City of Phoenix Office of the City Engineer Design and Construction Procurement

HAPPY VALLEY ROAD: 67TH AVENUE TO 35TH AVENUE ROADWAY IMPROVEMENTS DESIGN-BID-BUILD

> PROJECT NO. ST85100437 FEDERAL AID NO. PHX-0(363)D ADOT TRACS NO. T0239 01C

ADDENDUM NO. 2

DR: RJN | DES: ASF | CK: TJC | DWG. NO. G-2.03 | CK: G-2.

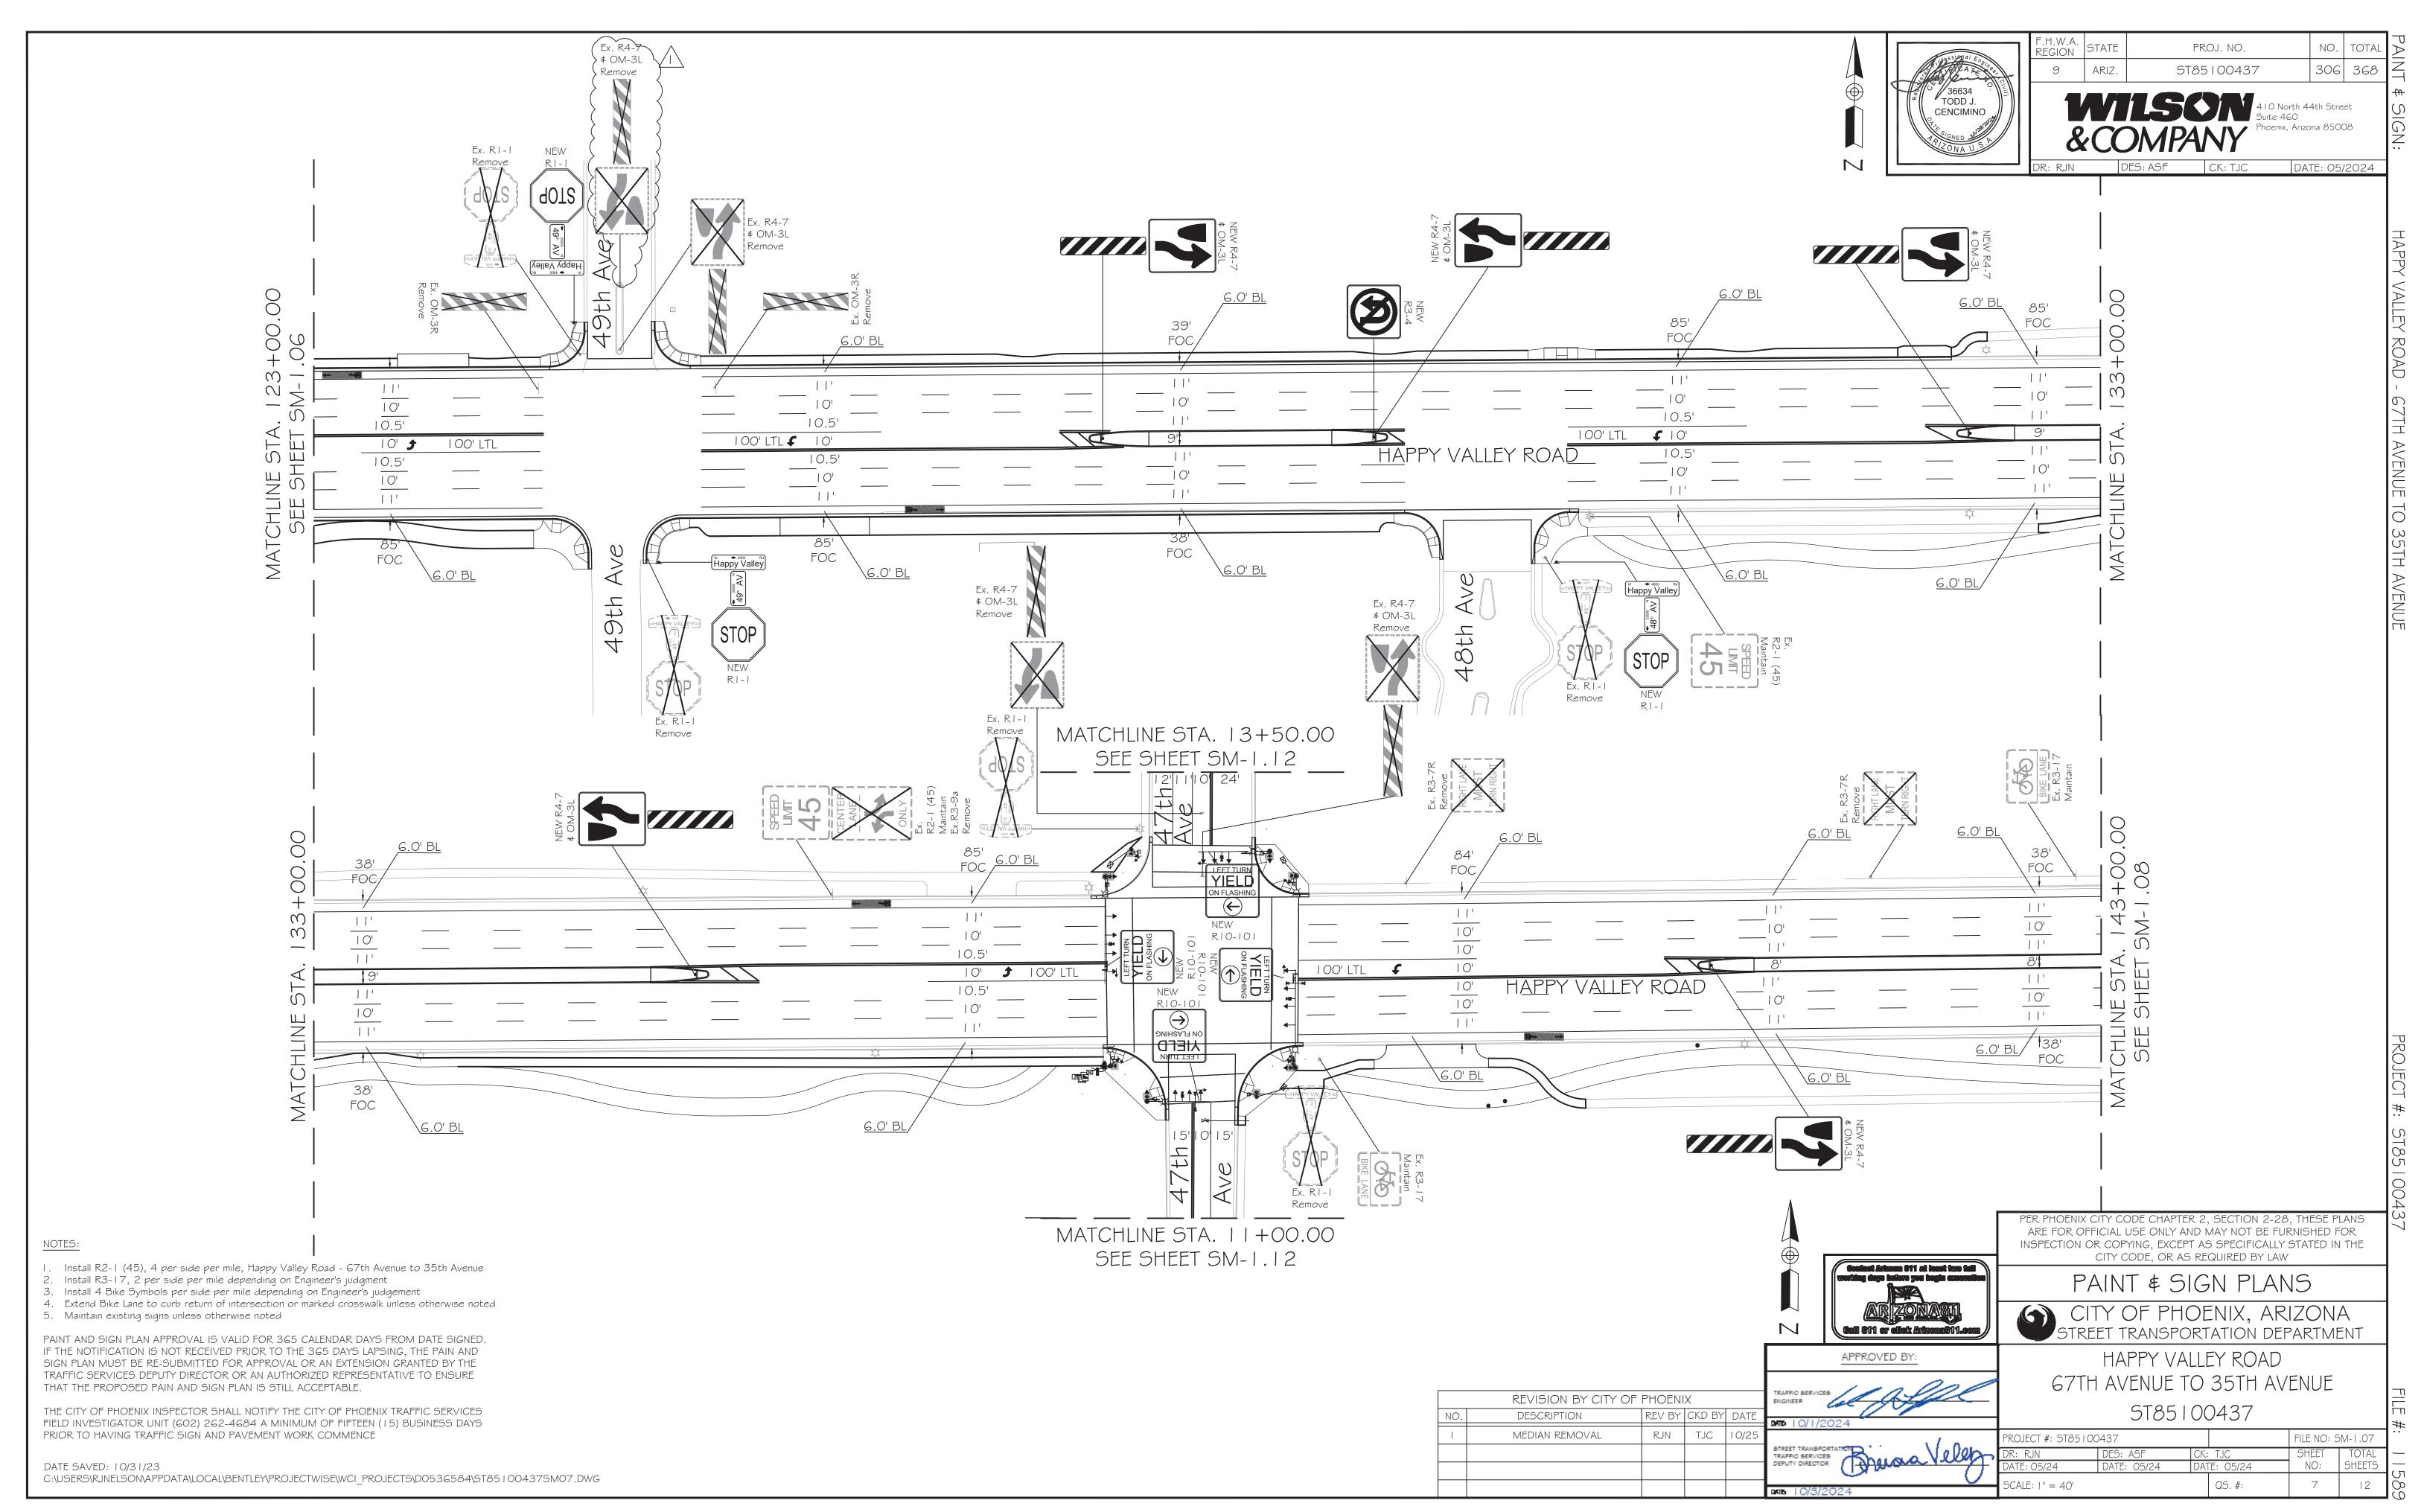
- Q21. Clarify what electrical materials are being provided and installed by the City. The special provisions, pay items and the traffic signal plans and details (specifically note 3) contradict each other.
- A21. Plans: Note 3 on Wilson & Company's traffic signal sheets reflects a non-federal aid note to contractors. See attached revised plans. Replace Note 3 on sheets 320, 328, 336, 344, and 346 with the following:
 - 3. WORK TO BE PERFORMED BY CITY OF PHOENIX SIGNAL CREWS
 Traffic Signal representative shall approve marked layout of ADA ramps, junction boxes
 and foundation locations prior to excavation, prep contractor furnished controller
 cabinets and internal equipment (contractor to pick up and install controller cabinet),
 inspect and approve all traffic signal equipment installed by contractor and terminate,
 test, and activate all field wiring into controller cabinet(s).
